SUBDIVISION REVIEW SHEET**CASE NO.:** C8-2021-0152.2A**COMMISSION DATE:** May 23, 2023**SUBDIVISION NAME:** Pinnacle at Wildhorse Ranch Section 2**ADDRESS:** 12000 Blue Bluff Road**APPLICANT:** Texas WH200, LP (Peter Dwyer)**AGENT:** Kimley-Horn & Associates (Kevin J. Burks, P.E.)**ZONING:** Wildhorse Ranch Planned Unit Development (PUD)**NEIGHBORHOOD PLAN:** N/A**AREA:** 16.13 acres**LOTS:** 54**COUNTY:** Travis**DISTRICT:** 1**WATERSHED:** Gilleland Creek**JURISDICTION:** Full Purpose**SIDEWALKS:** Sidewalks will be constructed along both sides of the internal street.**VARIANCE:** N/A**DEPARTMENT COMMENTS:**

**CITY OF AUSTIN –DEVELOPMENT SERVICES DEPARTMENT
SUBDIVISION APPLICATION – MASTER COMMENT REPORT**

CASE NUMBER: C8-2021-0152.2A
UPDATE: U2
CASE MANAGER: Juan Enriquez, Senior Planner juan.enriquez@austintexas.gov

PROJECT NAME: Pinnacle at Wildhorse Ranch Section 2
LOCATION: 12000 BLUE BLUFF RD

**PINNACLE AT
WILDHORSE RANCH SECTION 2**

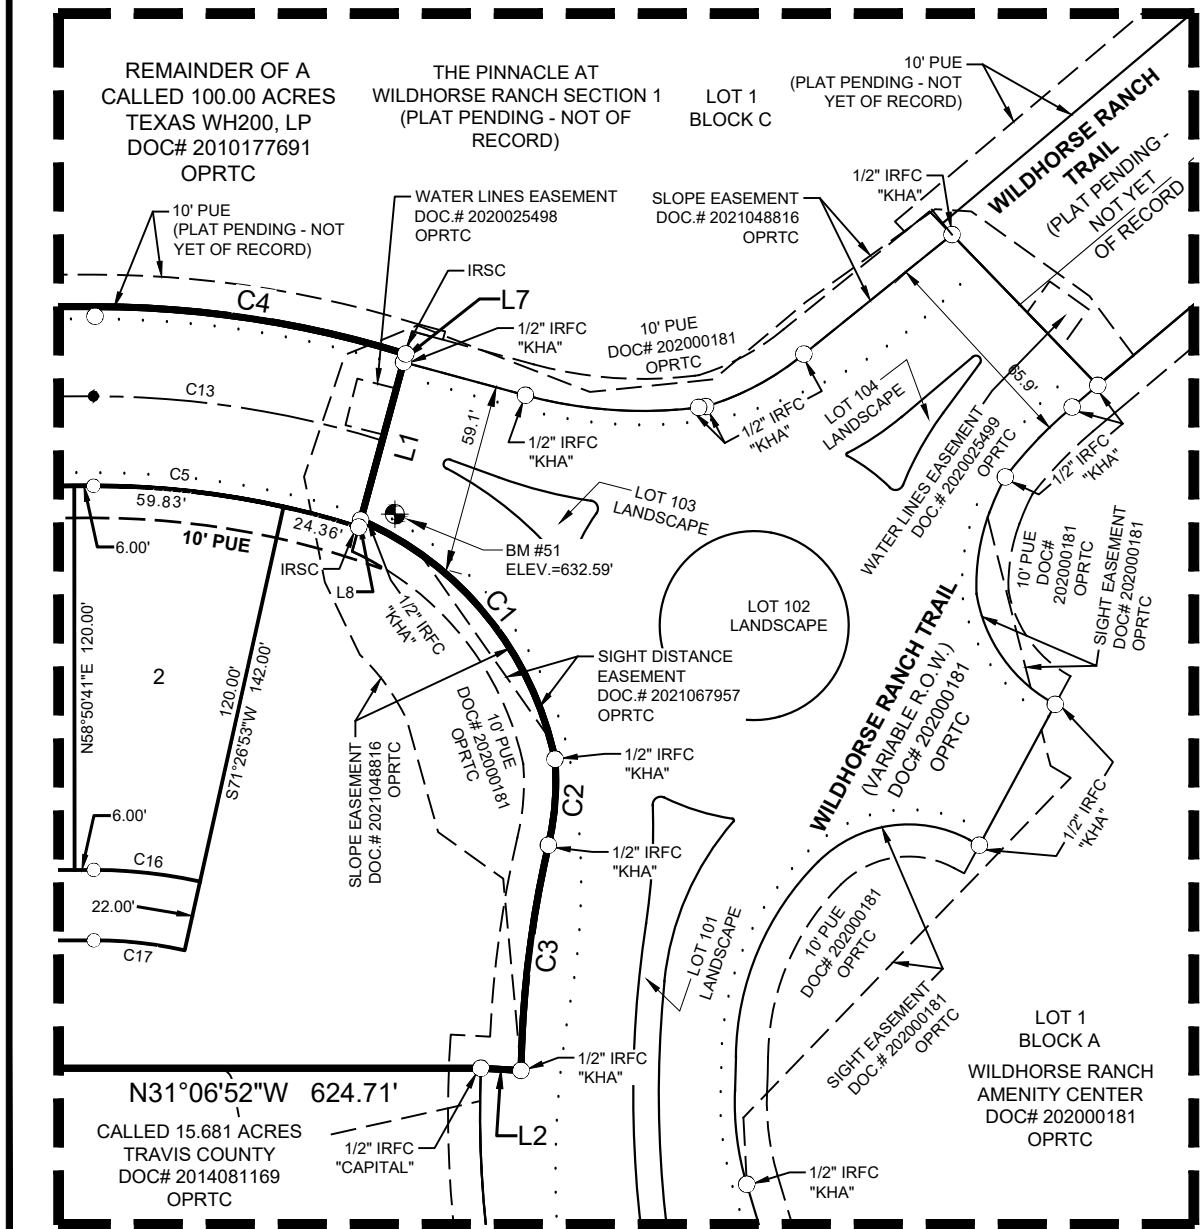
AD2: Please clarify whether the street will continue north beyond the platted area and email addressing@austintexas.gov for correspondence with the subject line: Street Name C8-2021-0152.2A
Pinnacle at Wildhorse Ranch Section 2

AD3: GOLDEN RODEO CV is reserved for Pinnacle at Wildhorse Ranch but is more than 600' ft. Please relabel as GOLDEN RODEO RUN if the street ends at the plat boundary
